WESTHIDE SOLAR

Addendum Ecology Report

Ersun (Westhide SPV) Ltd

October 2022

CLIENT: ERSUN (WESTHIDE SPV) LTD
PROJECT: WESTHIDE SOLAR
TITLE: MASTERPLAN

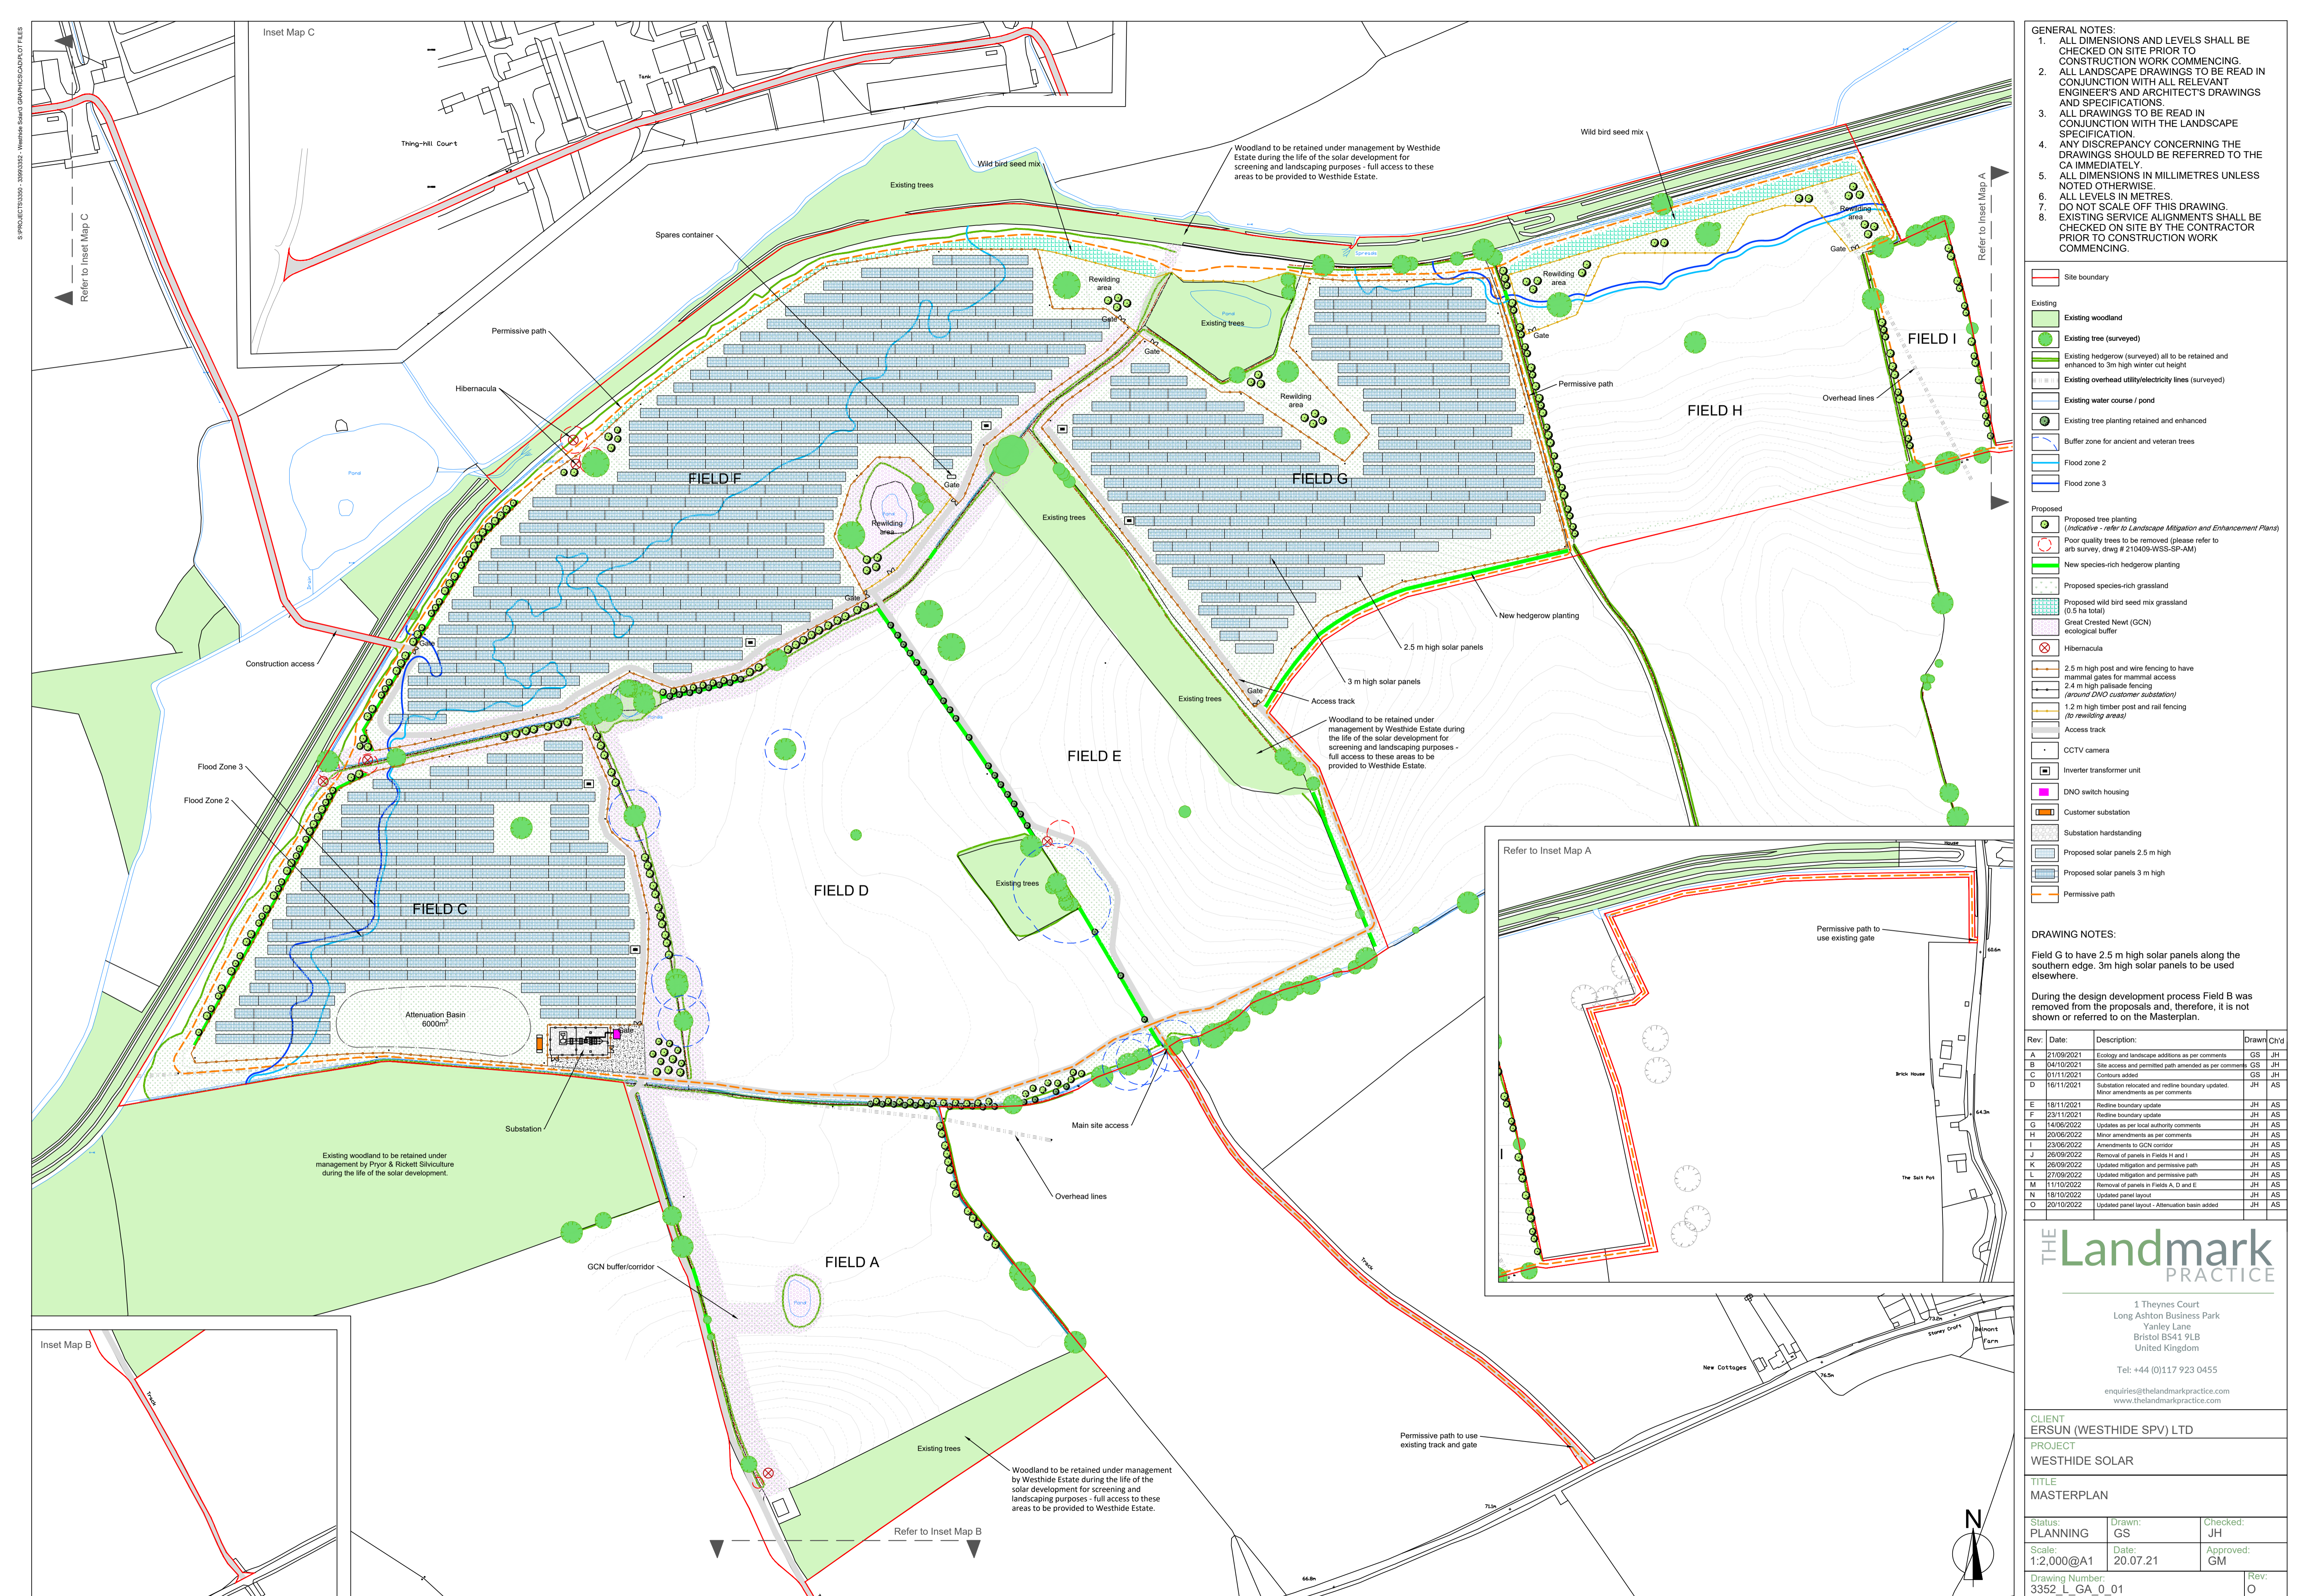
- 2.1 The following amendments to the site layout have been incorporated since the previous Ecological Addendum was issued:
- Removal of proposed solar panels and associated infrastructure in Fields A, D, E, H and I, these fields will be retained for arable use;
 - Associated removal of proposed hedgerow/boundary tree planting due to reduced need for visual screening and/or retaining original field sizes in the following areas: south of Fields A, H and I, west and east of Field A, and north-east of Field H;
 - Incorporation of a 6000 m² attenuation basin within Field C; and
 - Relocation of footpath through field I, removing the requirement for creating a small gap in the hedgerow.

- 3.1 The proposals continue to avoid potential ecological impacts by retaining boundary features and confining development to the interior of fields currently in arable rotation. Impacts on boundary features are reduced as the redirection of the footpath avoids the need for creating the previously proposed gap in the hedgerow within field I.

- 3.2 The incorporation of a 6000 m² attenuation basin will increase the diversity of habitats offered by the scheme, as the plant species present in this area will be more suited to marshy conditions than across the rest of the site, and the feature will likely be seasonally wet offering increased wetland habitat to local fauna.

- 3.3 The retention of the fields listed above for arable use represents a decrease in the potential ecological value offered by the proposals in ecology terms, compared to the previous site design. This is due to the large area (c. 23.5 hectares) now to remain in arable rotation, a habitat of relatively low value to biodiversity, rather than being converted to species-rich grassland, a habitat of greater value to biodiversity. The level of proposed hedgerow/tree planting for visual screening has also accordingly been reduced.

Field G to have 2.5 m high solar panels along the southern edge. 3m high solar panels to be used elsewhere.
